Permit Number: 091336

This is to certify that CLANCY JEFFREY M & MARIE PLATT CLANCY ITS
has permission to Add Dormers, interior upgrades and interior renovation DEC 10 2009
AT 31 OBRION ST CB 003 K010001

City of Portland, Maine - Building or Use Permit Application

CLANCY REMODEL

31 OBRION ST PLOT PLAN

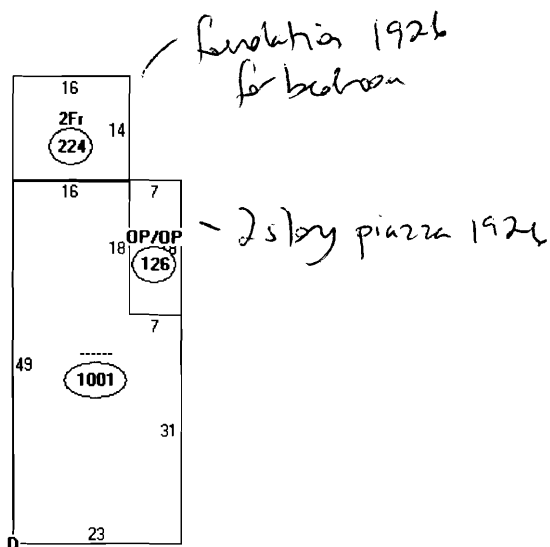
Dept: Zoning	Status: Approved with Conditions	Reviewer: Ann Machado	Approval Date: 12/04/2009
Note: Using section 14-436(b), 80% of the first floor footprint is 1080.8. Two dormers are adding 143 sf which is 13.23% of allowable 80% increase. Ok to Issue: <input checked="" type="checkbox"/>			
<ol style="list-style-type: none"> 1) This property shall remain a two family dwelling. Any change of use shall require a separate permit application for review and approval. 2) This permit is being approved on the basis of plans submitted. Any deviations shall require a separate approval before starting that work. 			
Dept: Building	Status: Approved with Conditions	Reviewer: Residential Plan Revie	Approval Date: 12/10/2009
Note: Ok to Issue: <input checked="" type="checkbox"/>			
<ol style="list-style-type: none"> 1) Separate permits are required for any electrical, plumbing, sprinkler, fire alarm or HVAC or exhaust systems. Separate plans may need to be submitted for approval as a part of this process. 2) Application approval based upon information provided by applicant. Any deviation from approved plans requires separate review and approval prior to work.

Use section 14-436(b) 80% of 1351 = 1080.8
 adding 3.25 x 22 71.5 x 2 = 143
 uses 13.23%
